PRELIMINARY ENGINEER'S REPORT

COMMUNITY WASTEWATER MANAGEMENT PROGRAM FOR THE HAMLET OF SHANDAKEN TOWN OF SHANDAKEN ULSTER COUNTY, NEW YORK

AMENDMENT #1

AMENDMENT #2

3 TYPICAL DETAIL FOR MULTIPLE PIPES IN THE SAME TRENCH
SCALE: N.T.S.

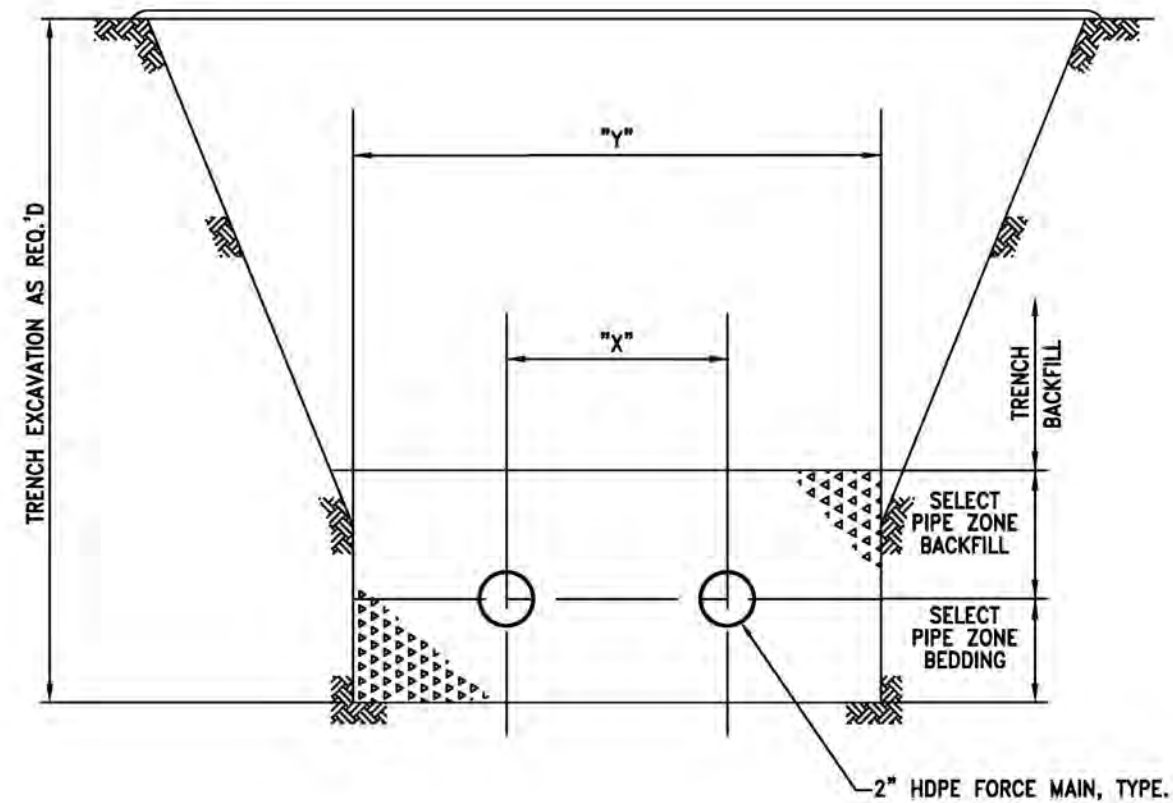
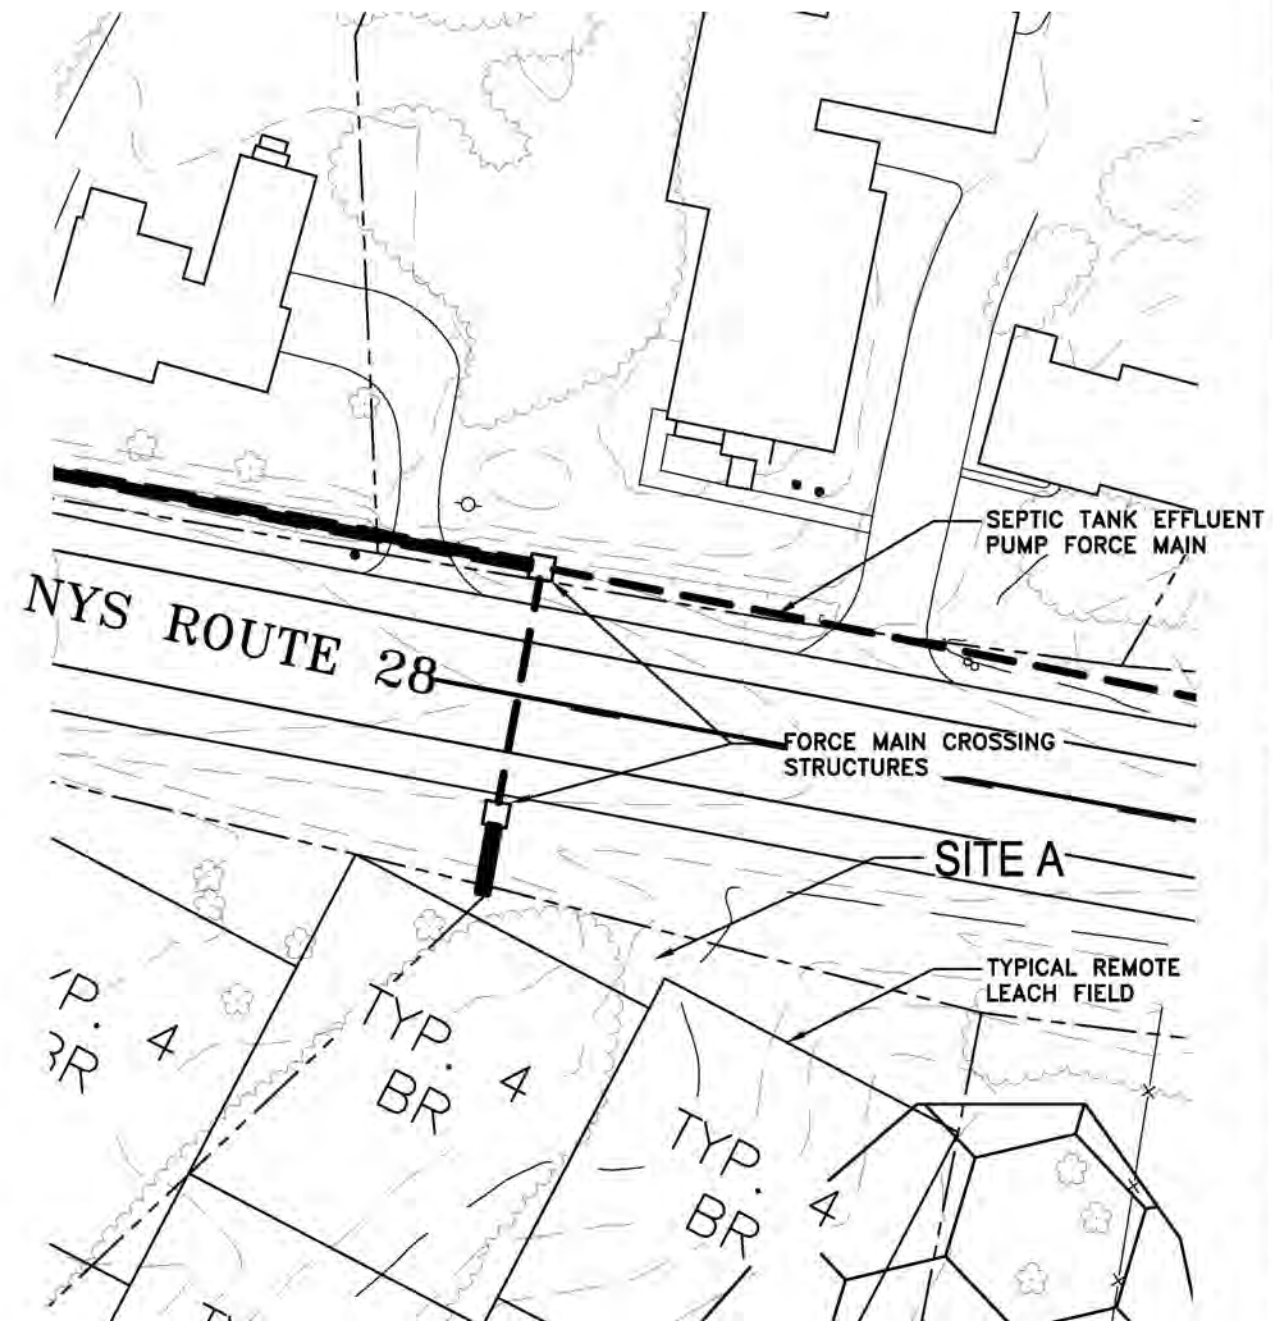
Please see the attached site plan which shows the relocation of the proposed septic tank effluent force mains outside of the NYSDOT pavement. Also attached you will find our proposed conceptual design details for multiple force mains in a single trench and multiple pipes crossing the NYSDOT ROW via one crossing.
